HIGHLAND CITY DEVELOPMENT ADMINISTRATION BOARD AGENDA

DEVELOPMENT ADMINISTRATION BOARD AGENDA REPORT ITEM #1

DATE: October 10, 2024
TO: Development Administration Board
FROM: Rob Patterson, City Attorney / Planning & Zoning Administrator
SUBJECT: **Final Plat Approval:** Ridgeview Plat L
TYPE: **LAND USE (ADMINISTRATIVE)**

ATTACHMENT 6

C4.2

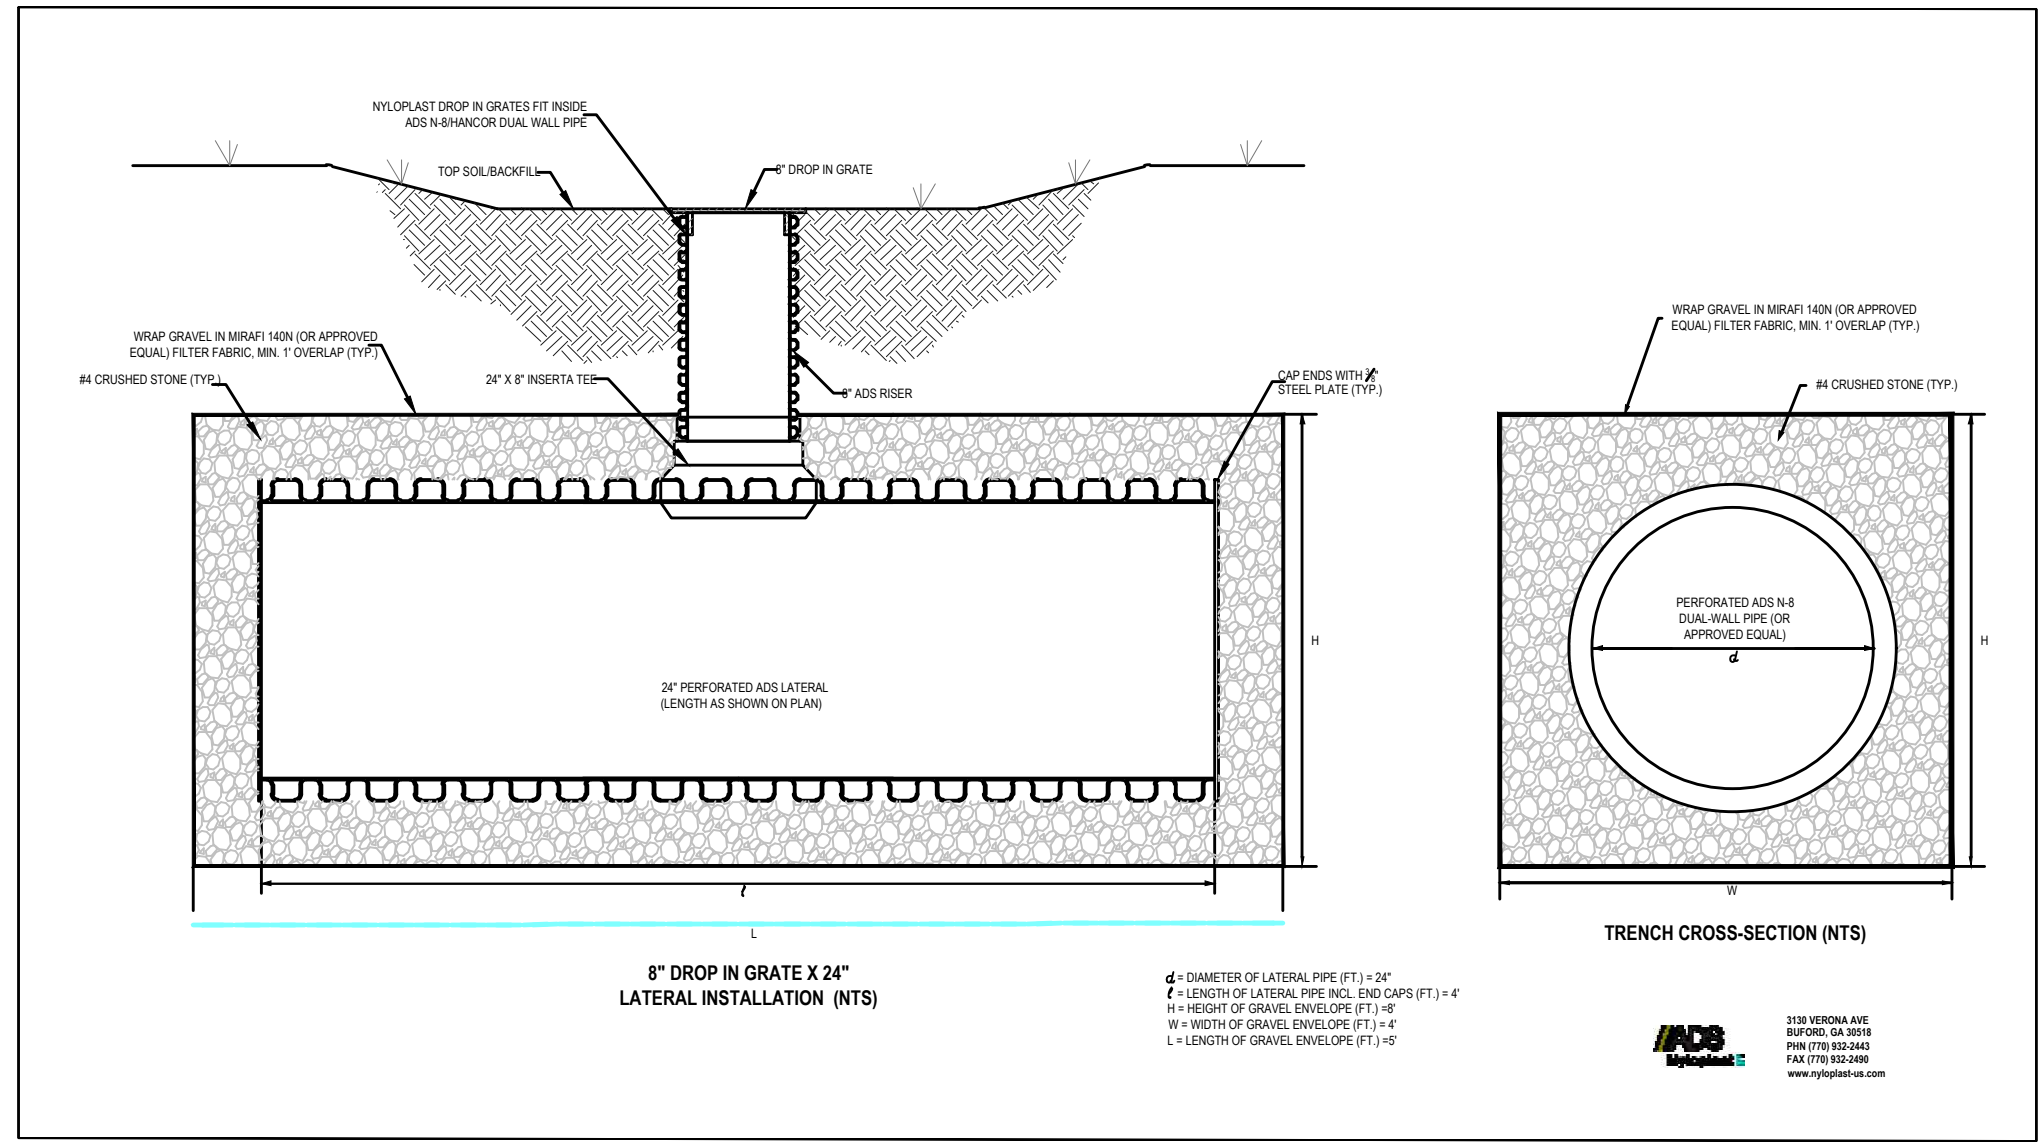
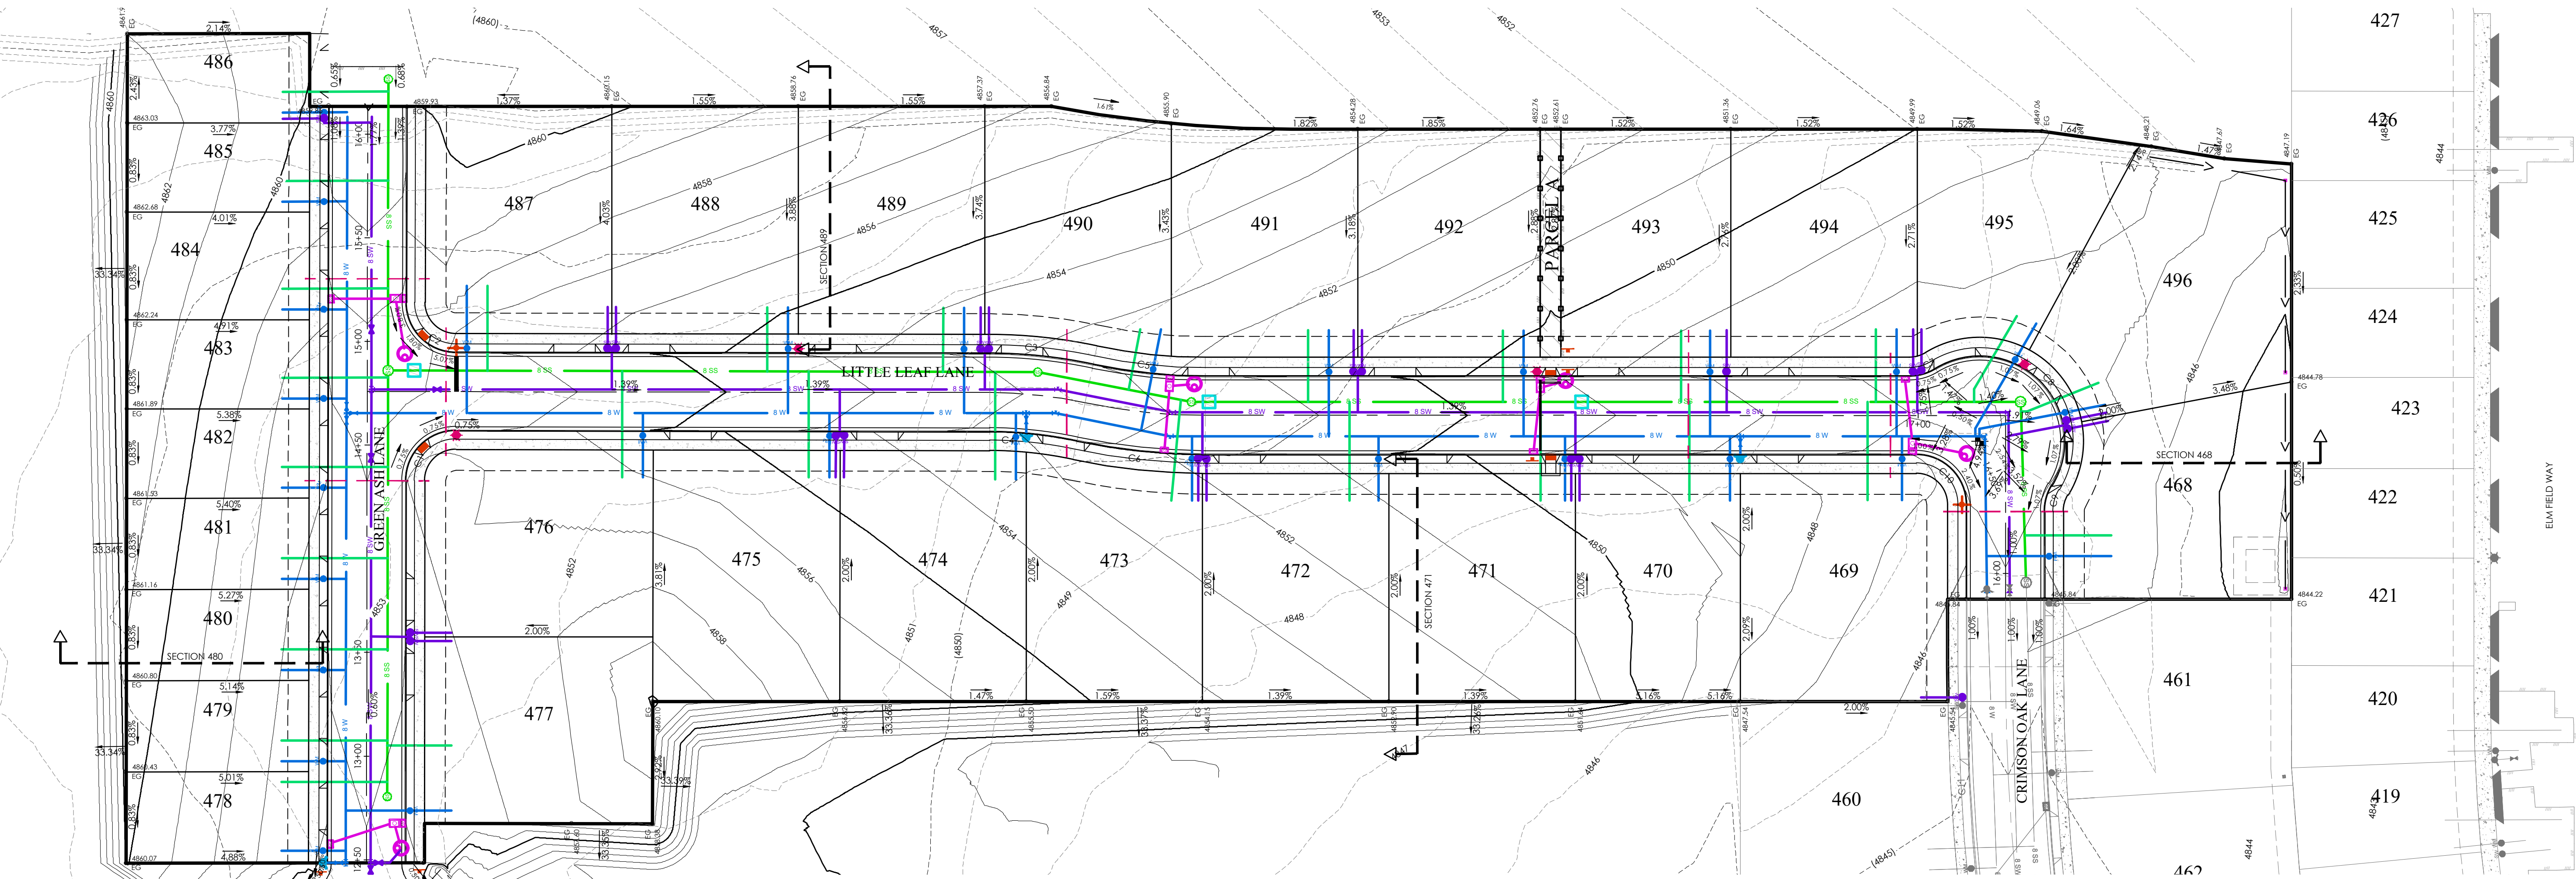
1. Temporary Turnaround: Symbol for 'No Parking Signs' added to sheet, but no details/spec/instructions provided. Provide enough detailed information so item can be approved by staff and built by contractor.
2. Crosswalk: Crosswalk shown, but no details/spec/instructions provided. Provide enough detailed information so item can be approved by staff and built by contractor.
3. Sumps: Storm drain report, Sheets C4-C4.2 (Grading and Drainage Plan):
APPLICANT RESPONSE IN GREEN (review comment #22):

- b. Revise the detail so it is readable, legible, and show what is to be built. Also, the calculations provided in the appendix of the drainage report for the rear yard sump do not share the same dimensions as the detail. Please revise.

-New response: The sump detail in the drainage report was revised and does match the detail included in the plan set.

-New response: There are two different sumps which are street sump and rear lot sumps. We added both to the drainage report and the rear lot sumps are shown on sheet C4.3.

Scale: 1"=20'
Date: 09/09/24
Sheet: PP01

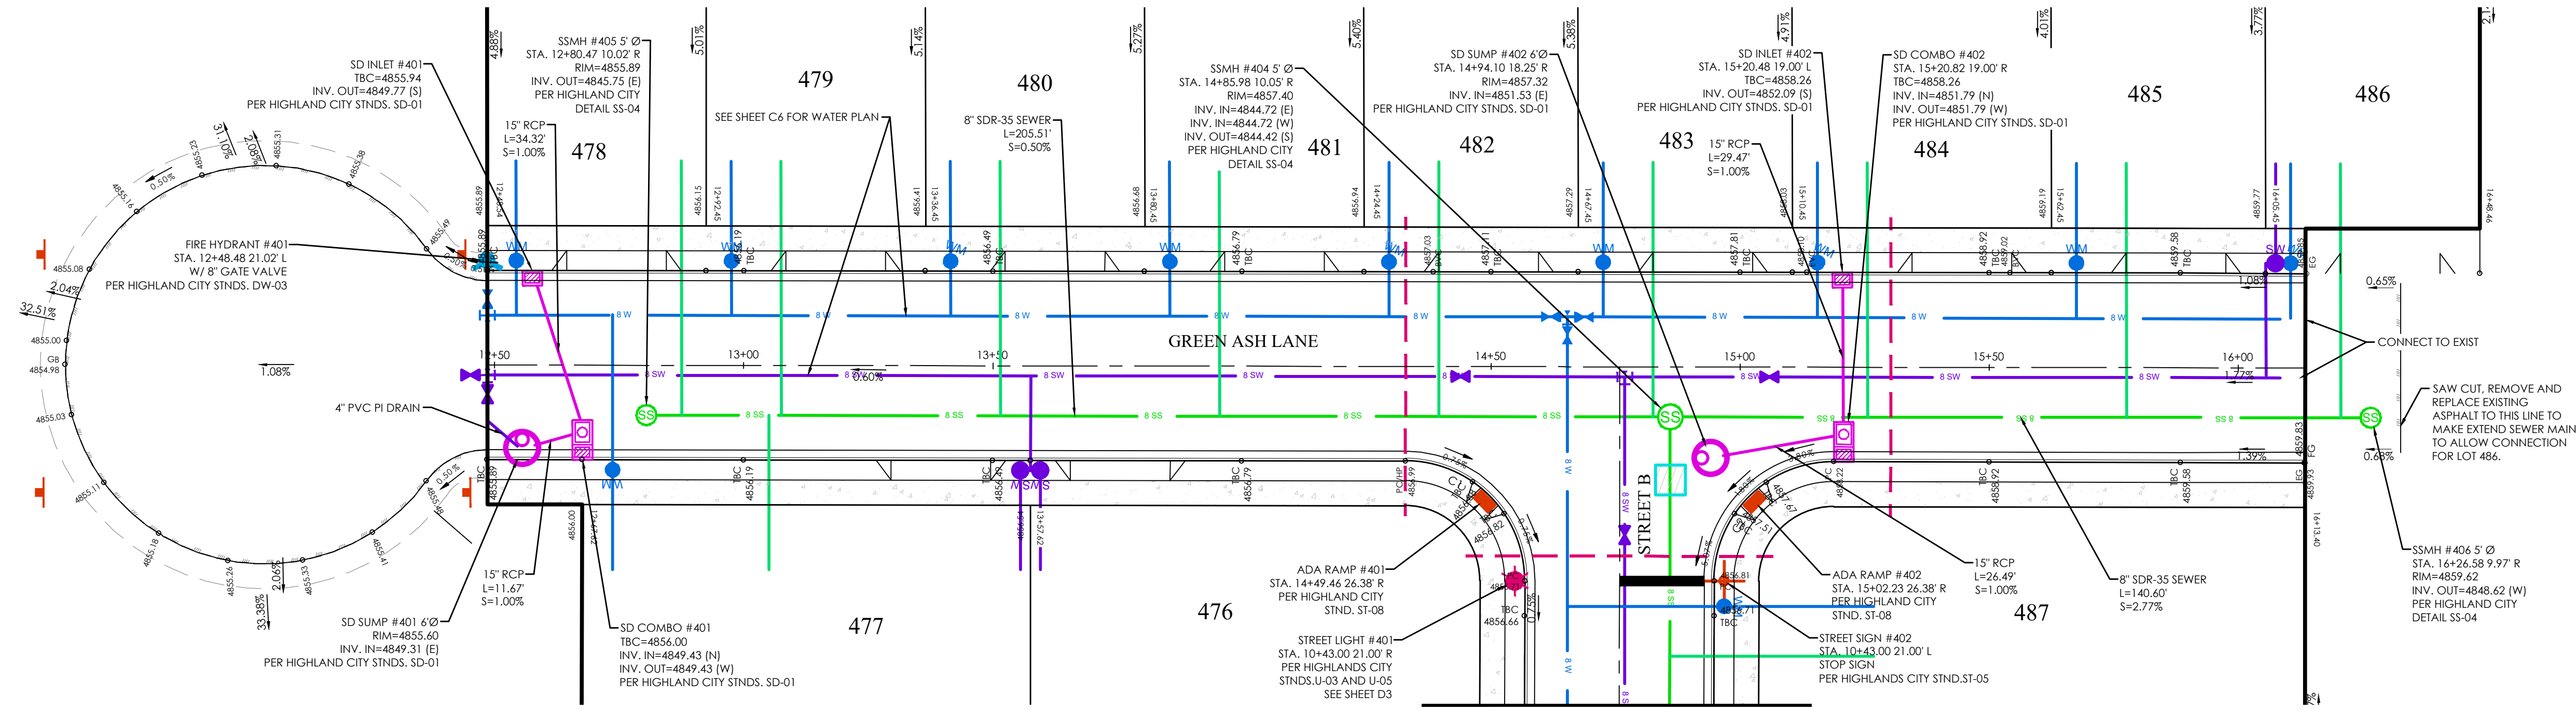
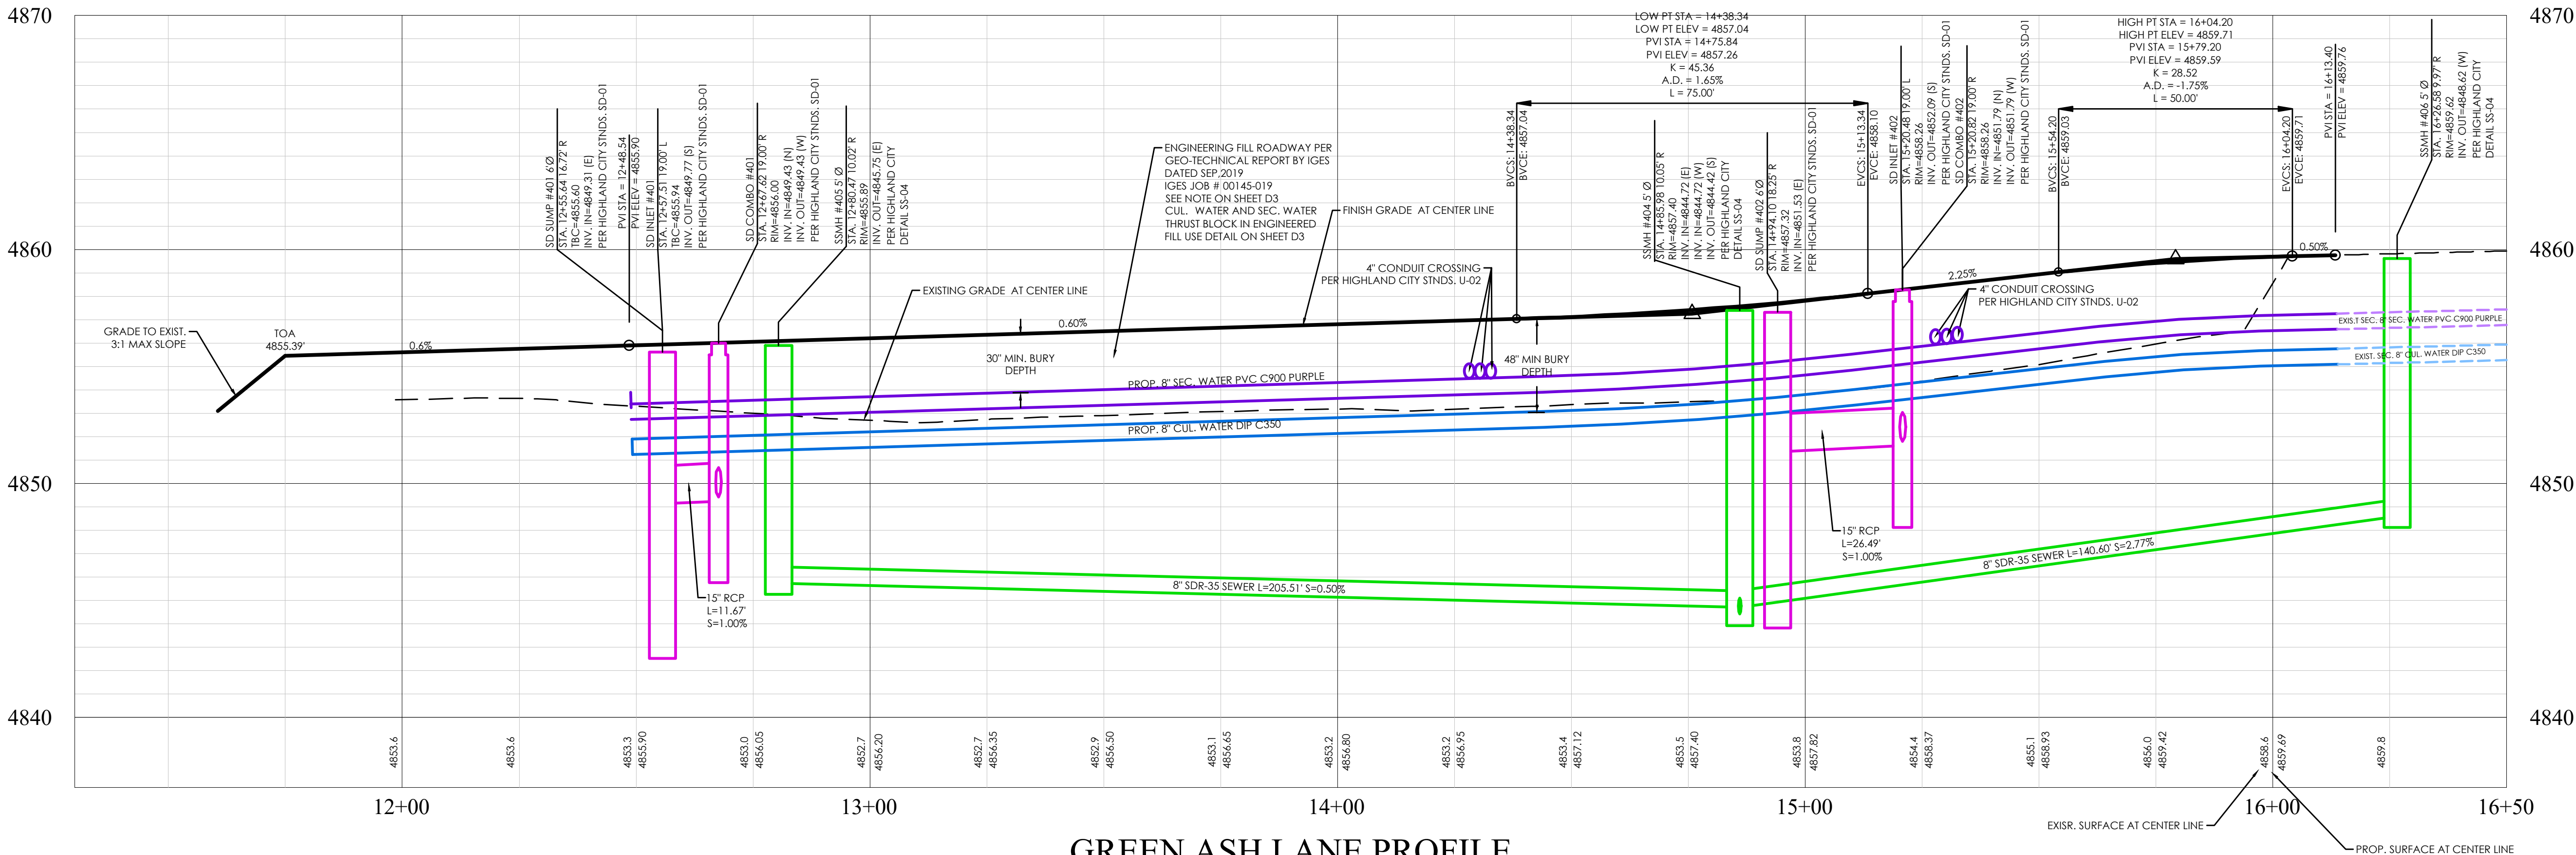
4. Green Ash Lane/Street B, Sheets PP01, PP02, PP03: Remove "Street B" from match lines and from plan views.
5. Crimson Oak Lane, Street Monument, Sheet PP04: Please provide reasoning for the location of the street monument. It does not mark the intersection of the two streets.
